Subdivision and Land Development Cover  
Page for SLD # 05-22

Project Name: Keith Catania

Address: 246 & 248 Hillcrest Avenue

**RE: Preliminary / Final Plan Review  
246 & 248 Hillcrest Avenue  
Whitemarsh Township, Montgomery County, PA  
S/LD # 05-22  
Our Project Number 2022-04048**

**EROSION CONTROL PLAN**

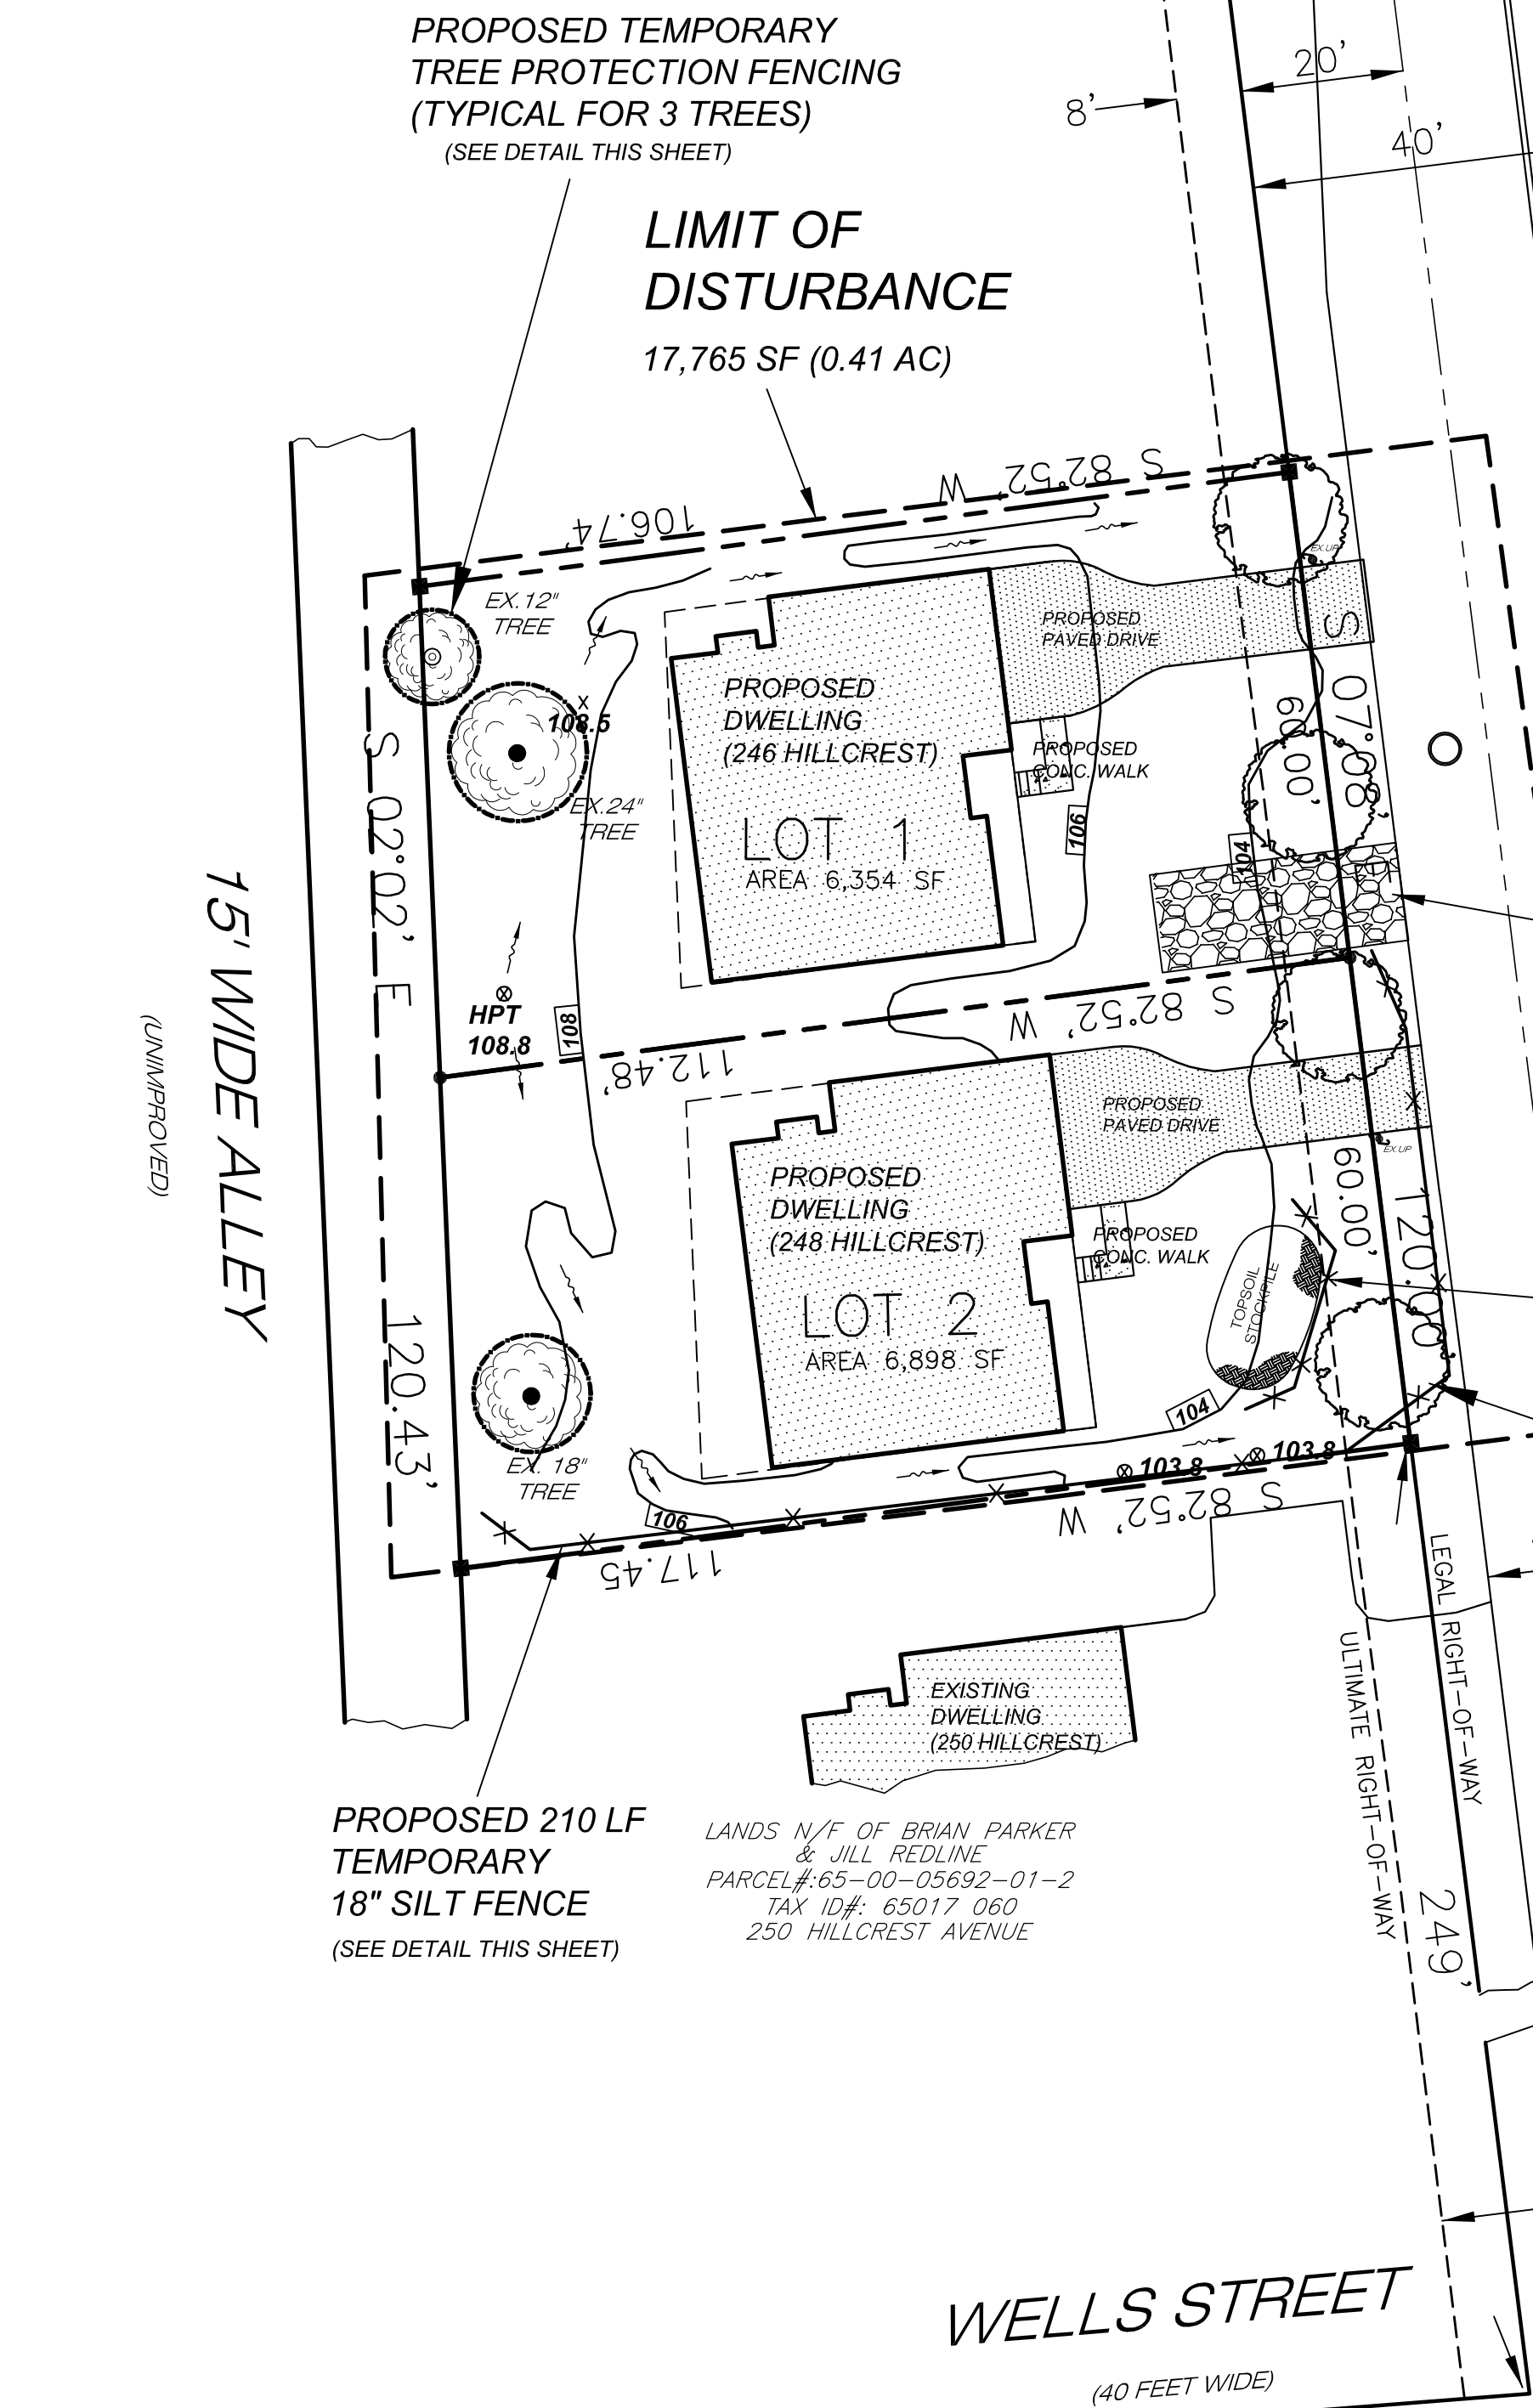
28. 58-12(B)	A note must be added to the Construction Sequence on Sheet 4 stating that plans for the earth disturbance activity, bearing the stamp of approval of the Township Engineer, shall be maintained at the site during the progress of the grading work and until the work has been completed.

29. 58-12(C)	A note must be added to the Construction Sequence on Sheet 4 stating the permit holder will notify the Township Engineer in order to obtain inspections at least 48 hours before the inspection is to be made for; initial inspection, rough grading, drainage facilities, BMPs, special structures and final inspection.

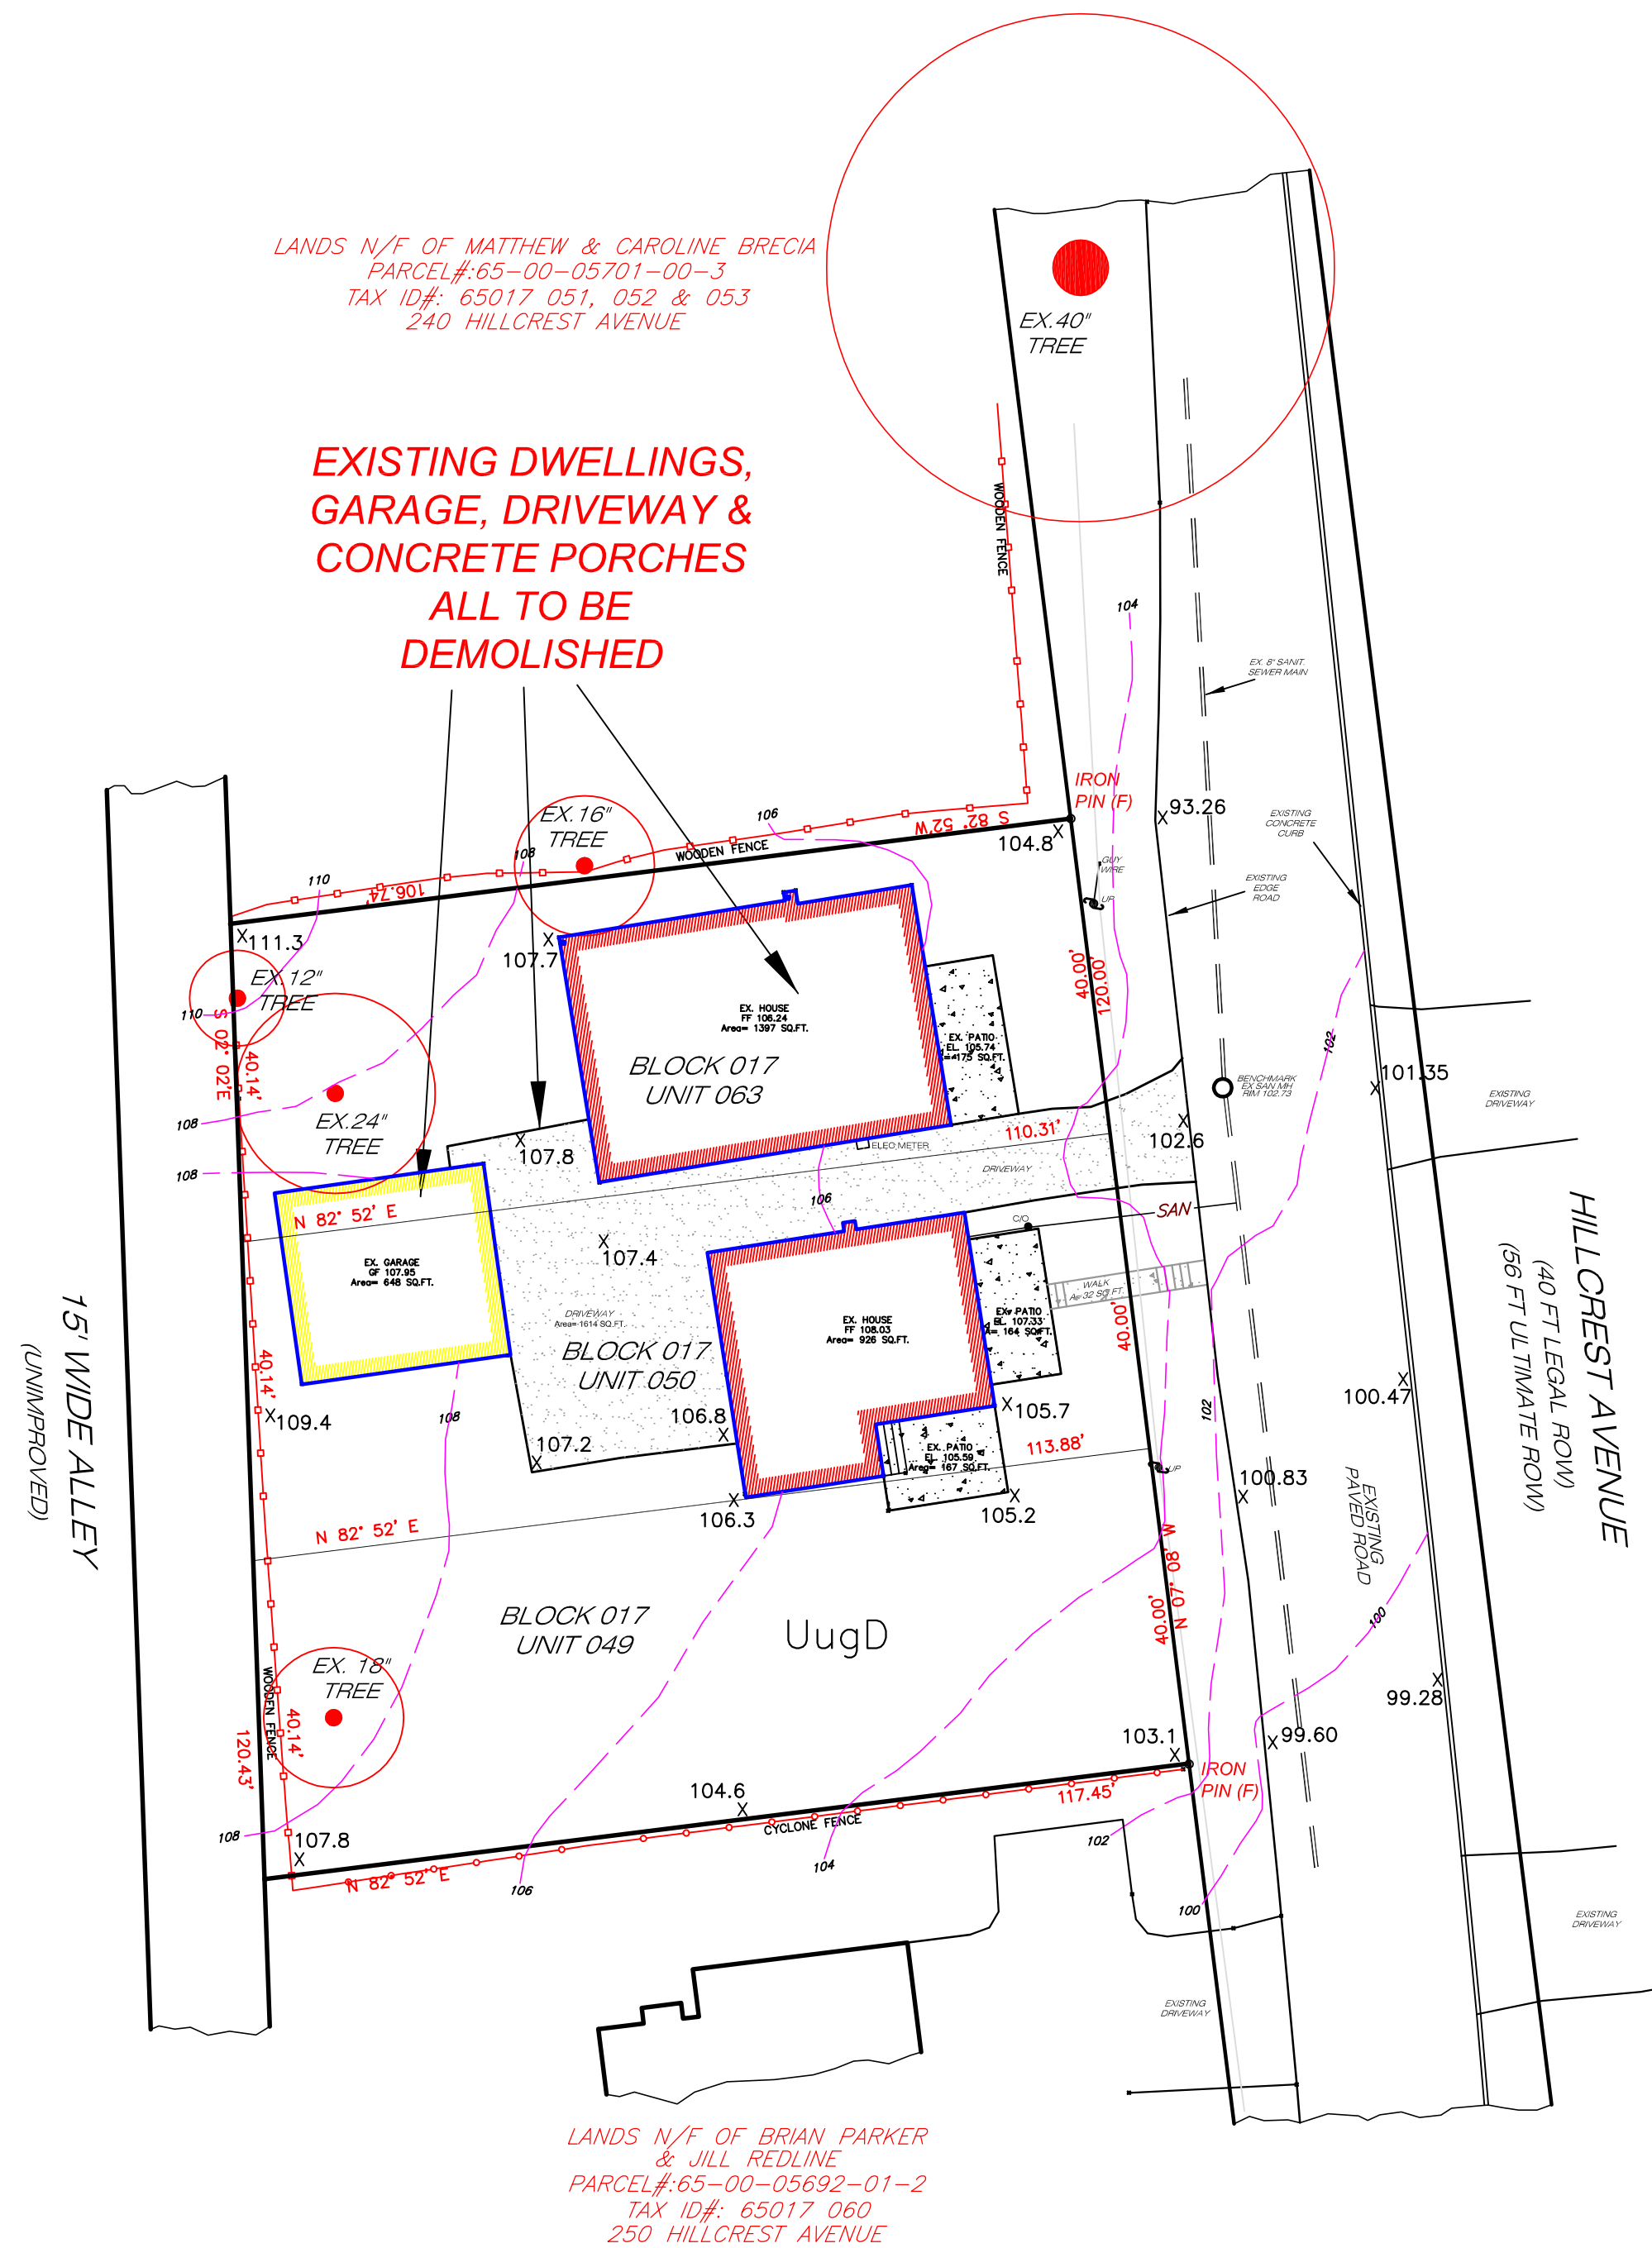
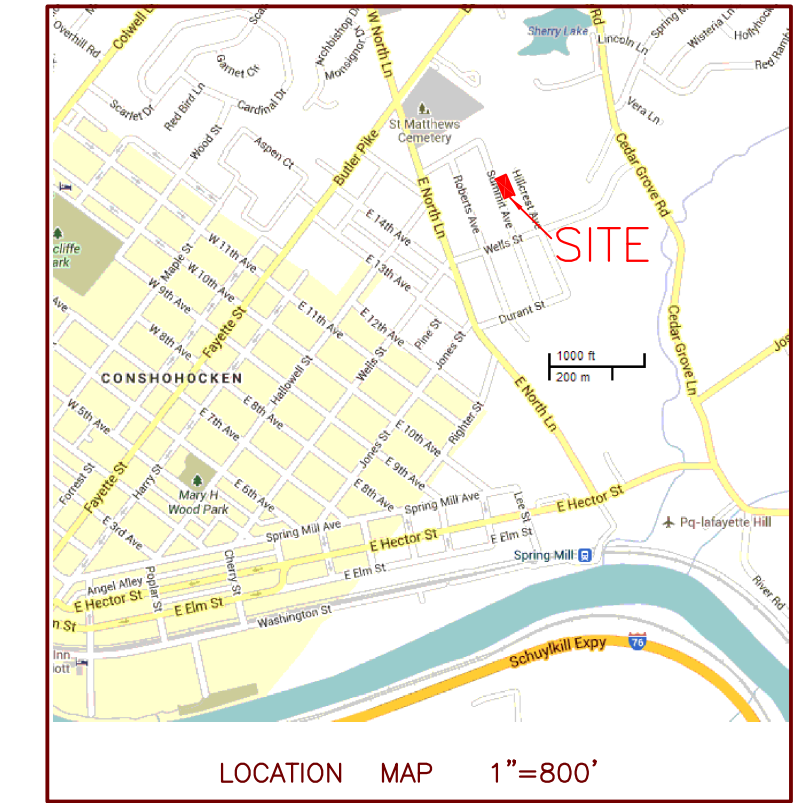
13.	105-23(B)	Sheet 5 must be revised to provide a legible Aerial Photo.
14.	105-24(B)(3)(d)	The area of the plan allocated for the signature of the Township Engineer must be revised to indicate 'Township', instead of 'Borough'.

1. APPLICANT IS REQUESTING A WAIVER FROM SECTION 105-21.B.(1)(n) SHOWING EXISTING FEATURES WITHIN 500 FEET OF SITE. THE PLANS DO SHOW IMPROVEMENTS 50' BEYOND THE PROPERTY. THE PLANS ALSO HAVE AN AERIAL PHOTO (SHEET 5 OF 5) TO SHOW IMPROVEMENTS FURTHER FROM THE SITE.
